ADDENDUM #02

Project Name:
Iowa DAS - DOC 4JD CBC New Central Office Building
DAS# 9488.00
RFB 948800-01
Addendum #02
Dated: May 07, 2026

ADDENDUM NUMBER TWO
To Contract Documents for:
IOWA DAS – DOC 4JD CBC NEW CENTRAL OFFICE BUILDING
SVPA Project No. 25079
Owner Project No. 9488.00

- (7) Pages REVISED Section 08 4113
- (7) REVISED Architectural Drawings A200, A300, A420, A421, A500, A511, A800

1 NORTH ELEVATION
SCALE: 1/8" = 1'-0"

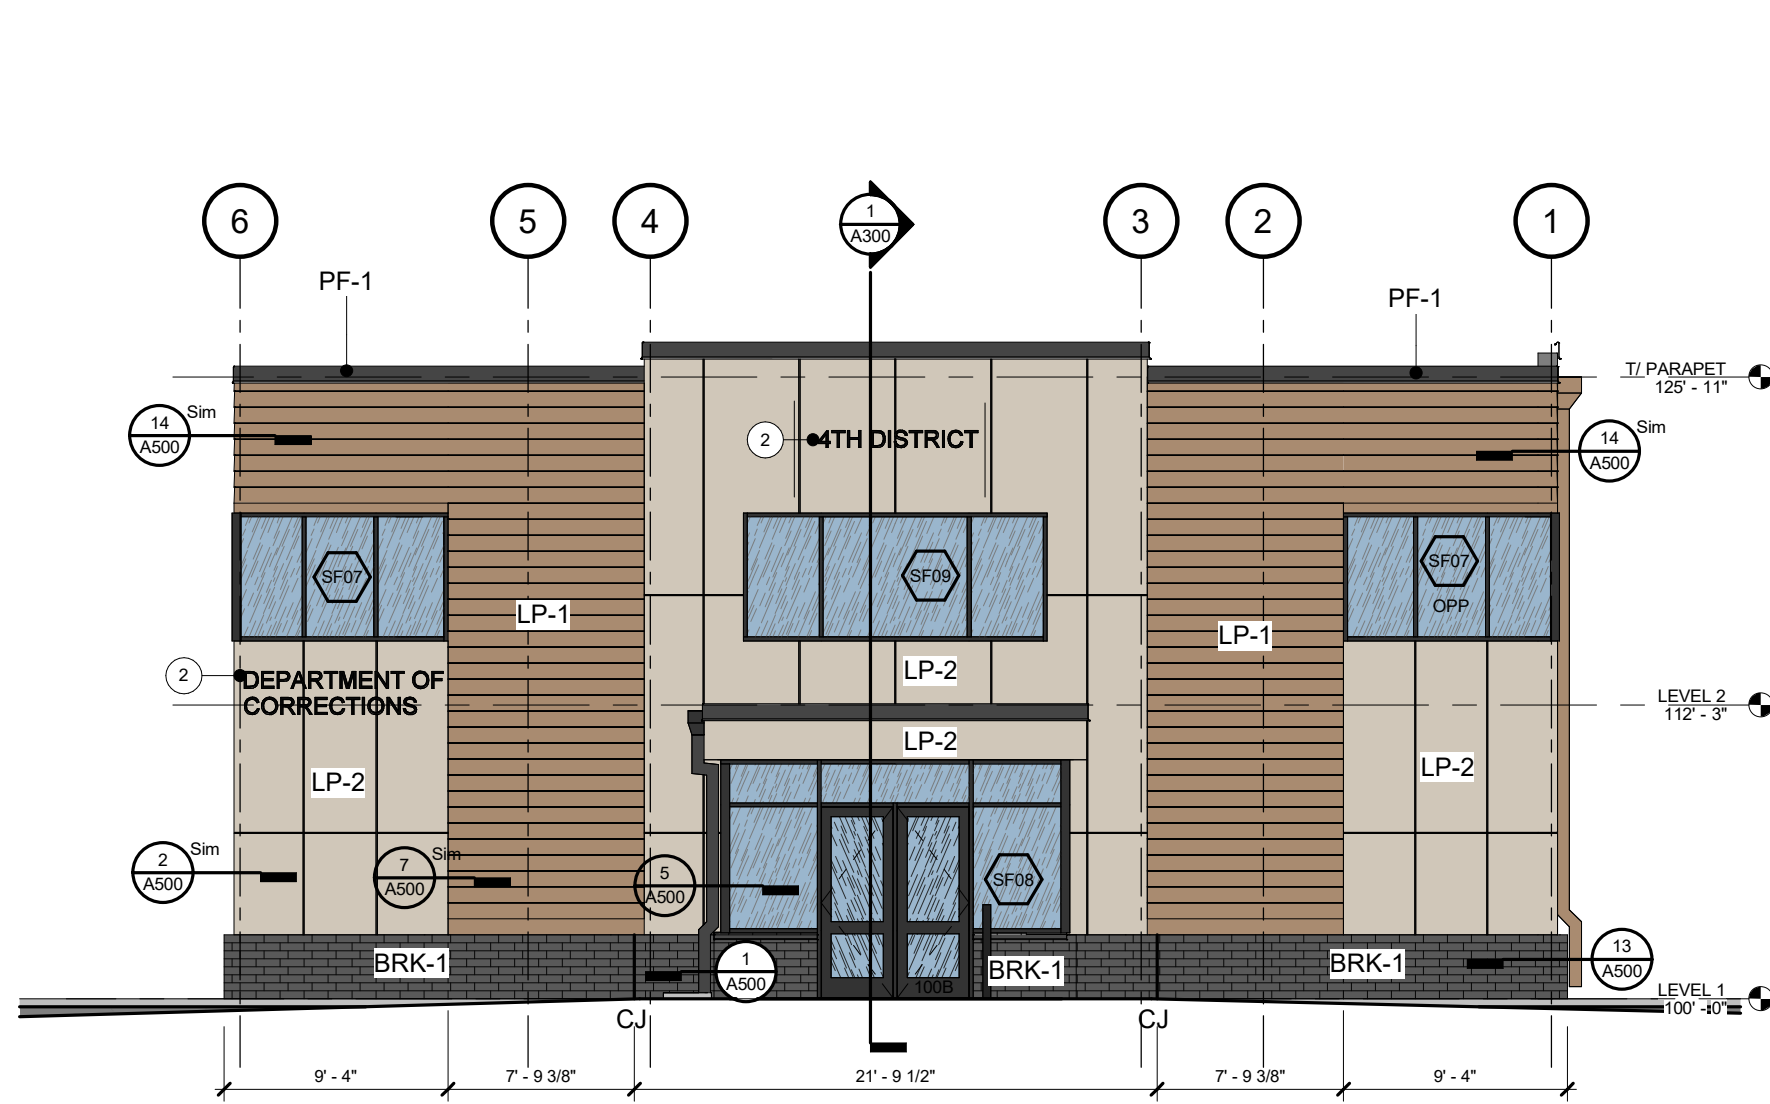
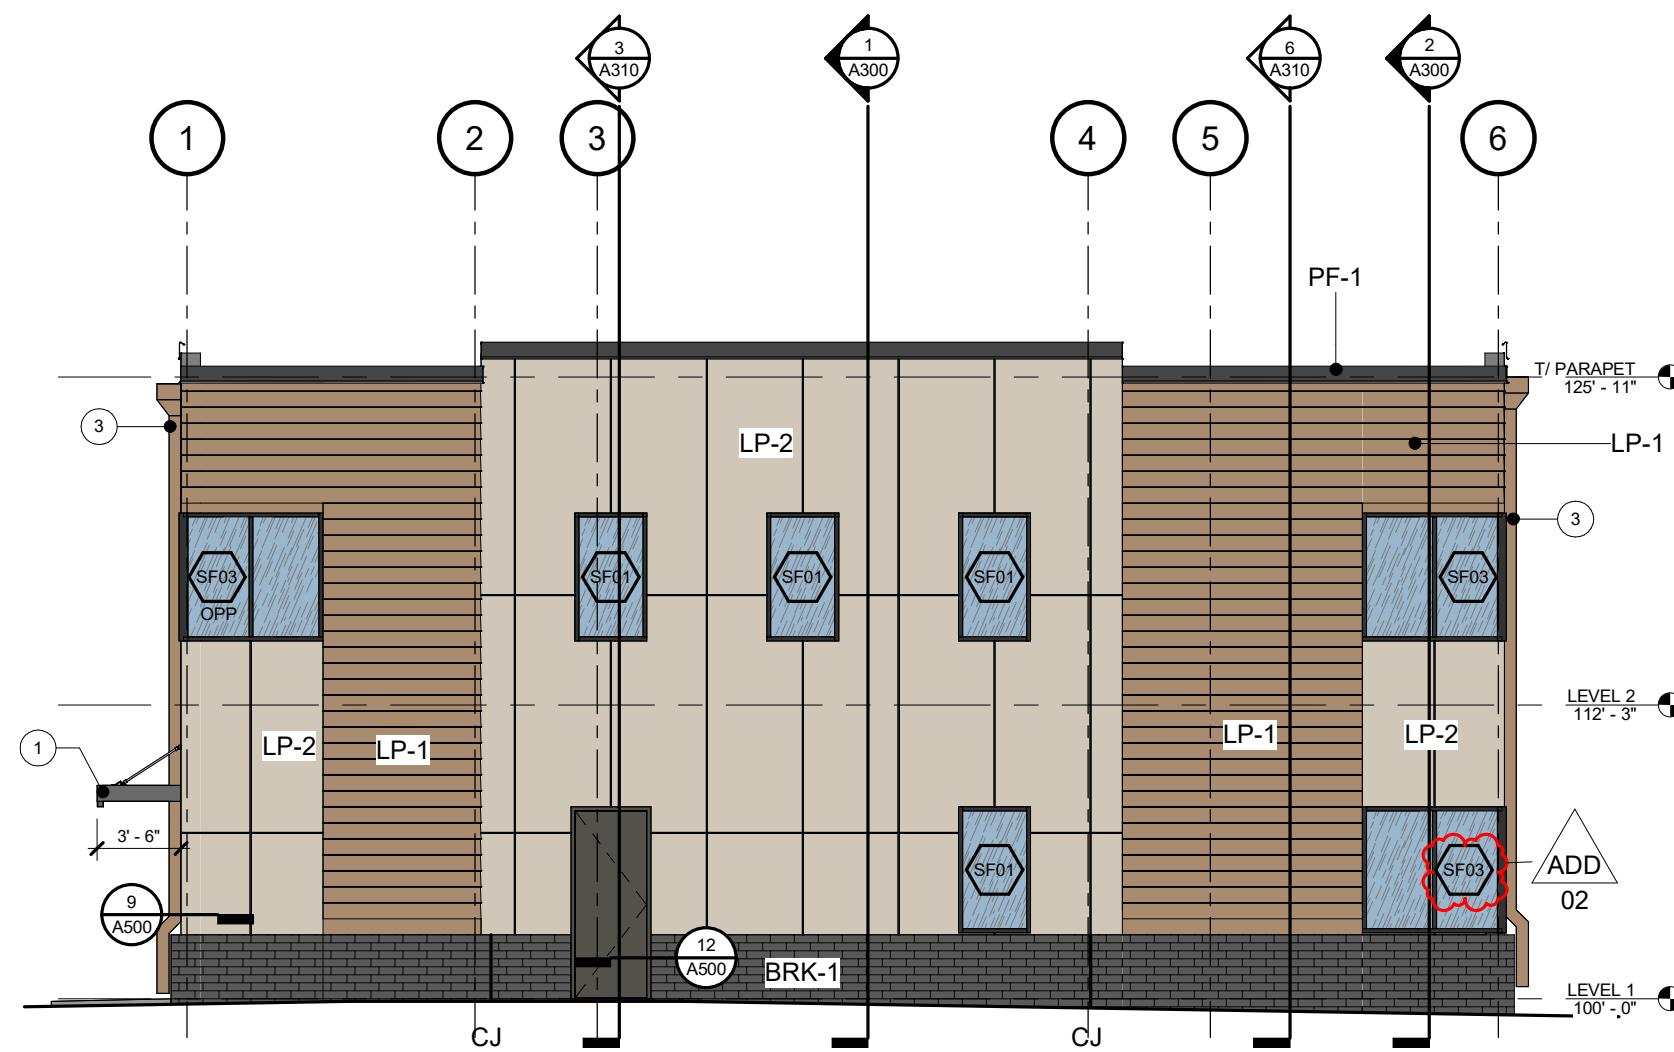
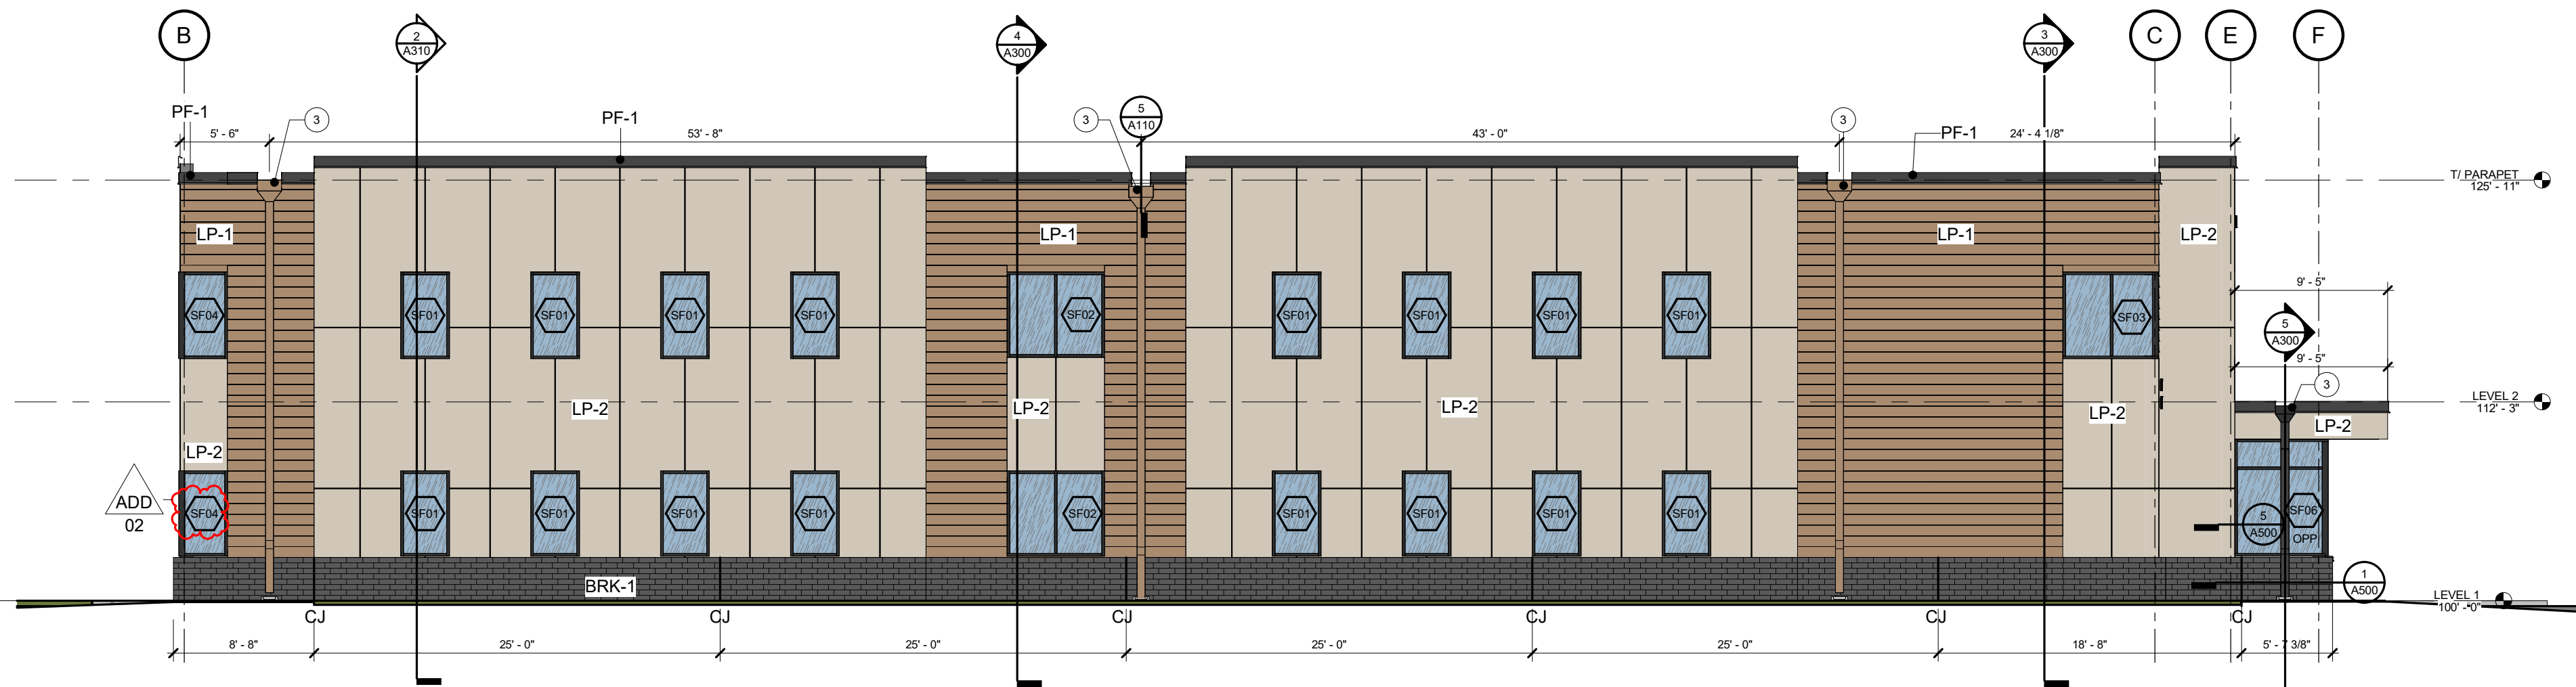
1. Sheet A200 – EXTERIOR ELEVATIONS

- A. ADD storefront tag to windows.
- B. See attached revised sheet A200.

2 BUILDING SECTION
SCALE: 1/8" = 1'-0"

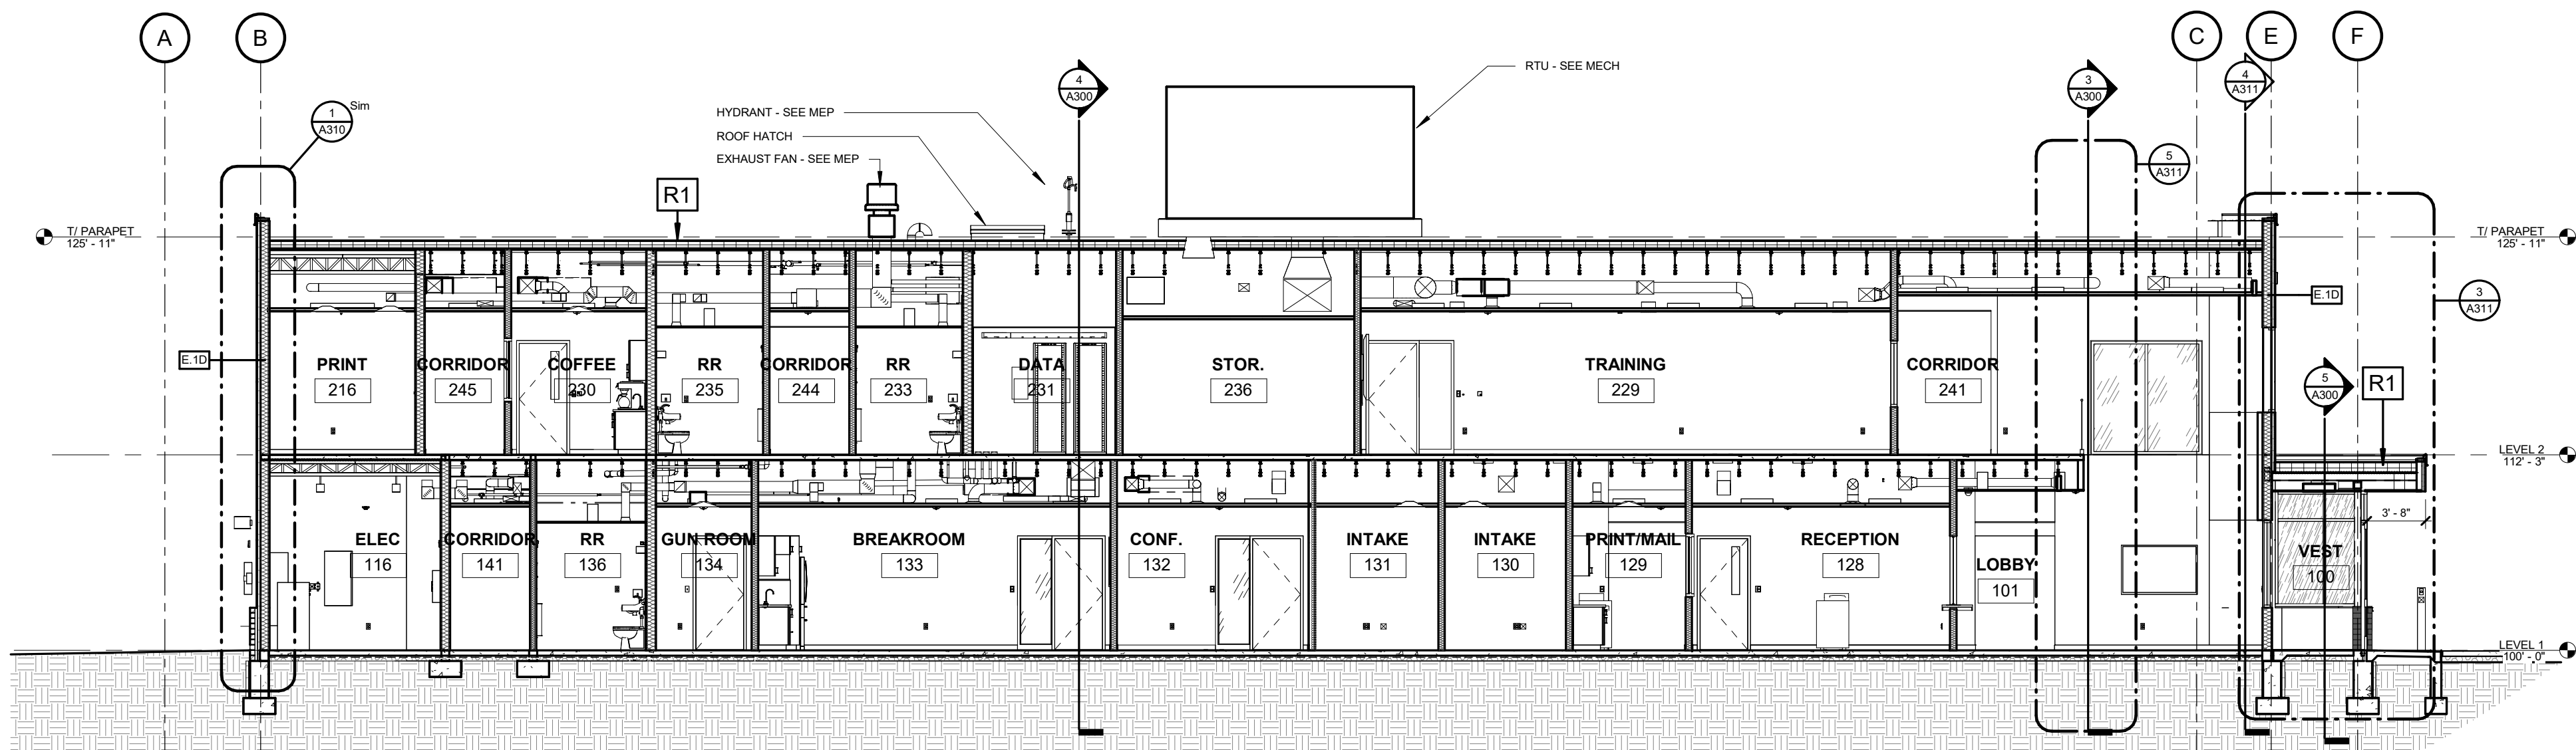
2. Sheet A300 – BUILDING SECTIONS

- A. ADD detail callout 8/A511 to building section 2.
- B. See attached revised sheet A300.

3 SF JAMB AT LP SIDING DETAIL
SCALE: 1 1/2" = 1'-0"

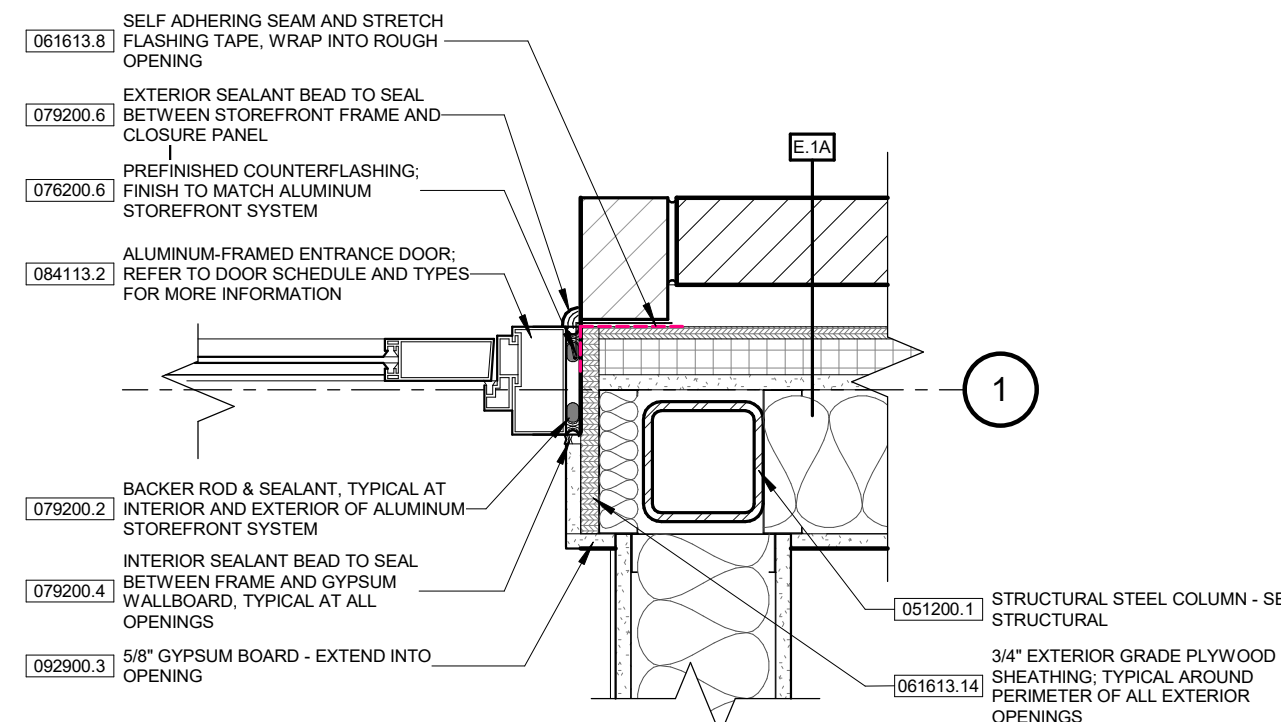
5. Sheet A500 – PLAN DETAILS

- A. REVISE detail 3 keynote.
- B. See attached revised sheet A500.
